Preliminary Information

PIP5681A Exhaust leak, Lean Codes, Rattle Noise, or Catalytic Converter Failures.

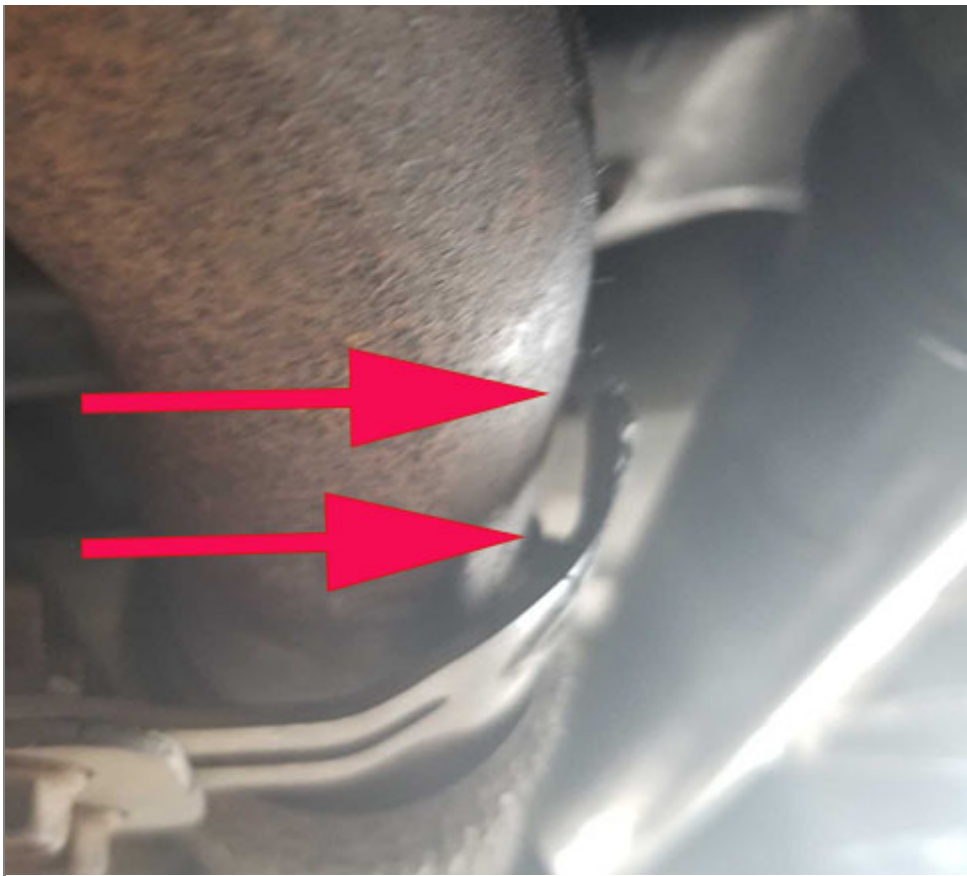
Involved Region or Country	North America
Condition	Some customers may complain of a rattle or exhaust noise, a CEL/MIL on, or repeat concerns of lean codes or converter failures. You may find a cracked pipe on Bank 2, a cracked catalytic converter on Bank 1, or any of these DTC's - P0171, P0174, P0420, P0430, P2096, P2097, P2098, or P2099.
Cause	The cause for these concerns could be a broken or poor weld with lack of penetration on the Bank 2 exhaust flex pipe bracket as shown below.

The correction for this concern is to replace the pipe from the Bank 2 converter to the mid exhaust assembly. Also inspect for damage to the right catalytic converter and pipes caused by the Bank 2 pipe being broken. Clear any codes that have set and retest the vehicle till the codes have run and ensure they pass.
